TO: To Whom It May Concern DATE: July 14, 2004

FROM: Andrew T. Ross,
Certified Arborist - MA0356

SUBJECT: Hilltop Subdivision; RZ 2004-PR-010

EXISTING VEGETATION MAP AND TREE PRESERVATION
FOR
LOT 18

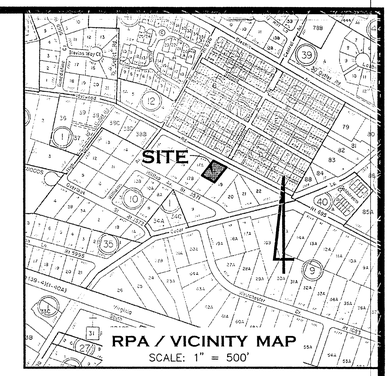
This letter is in response to Fairfax County Arborist, Todd Nelsons memorandum dated April 23rd, 2004. The following numbered items coincide with the memo's numbered comments.

1. The current EVM has been delineated on site plan.
2. A tree inventory has been provided showing the location, species, size, actual dripline and condition percentage for all trees 12 inches or greater in diameter on the entire site. The condition analysis ratings have been prepared using methods outlined in the latest edition of the Guide for Plant Appraisal.

3. The cover calculation will be performed by the engineer.
4. I have designated the following trees for removal as recommended: the 24 inch diameter chestnut oak tree (#8) located at the Northern portion of the property adjacent to Idylwood Road; the 30 inch diameter chestnut oak tree (#7) located at the Western portion of the site; and the 24 inch diameter chestnut oak (#13) located to the South of the existing shed.

5. Planting plan needs to be developed by the engineer or Landscape Architect and should be incorporated into cover calculations.
6. This language should be used as recommended. The tree preservation plan has been developed by a professional and this is now fulfilled.

7. The tree preservation includes a survey that includes location, species, size crown spread and condition rating percentage of all trees 12 inches in diameter and greater 10 feet to either side of limits of clearing and grading. The Urban Forestry Branch (Todd Nelson) has requested engineering requirements such as off-site clearing and grading for utilities and storm water outfall be depicted on the site plan. The condition analysis ratings are prepared using the methods outlined in the latest edition of the Guide for Plant Appraisal published by the International Society of Arboriculture. Specific tree preservation activities that will maximize the survivability of trees identified to be preserved, such as: crown pruning, root pruning, mulching, fertilization and others as necessary, are included in the plan.

8. Tree fencing has been indicated on the plan. Tree protection fencing four feet high, 14 gauge welded wire attached to six foot steel posts driven 18 inches into the ground placed no further that 10 feet apart, shall be erected at the limits of clearing and grading as shown on the demolition, and phase I & II erosion and sediment control sheets for the entire site. It appears that no activity will occur on the lot 18A and the fencing depicts this on the plan..

9. All tree protection fencing shall be installed prior to any clearing and grading activities, including the demolition of any existing structures. The installation of all tree protection fencing, except super silt fence shall be performed under the supervision of a certified arborist. Three days prior to the commencement of any clearing, grading or demolition activities, the Urban Forestry Division shall be notified and given opportunity to inspect the site to assure that all tree protection devices have been correctly installed.

10. Site monitoring: The developer shall retain the services of a certified arborist or Landscape Architect to monitor all construction work and tree preservation efforts in order to ensure conformance with all tree preservation/proffers/conditions. The monitoring schedule shall be described and detailed in the tree preservation plan, and reviewed and approved by the Urban Forestry Division.
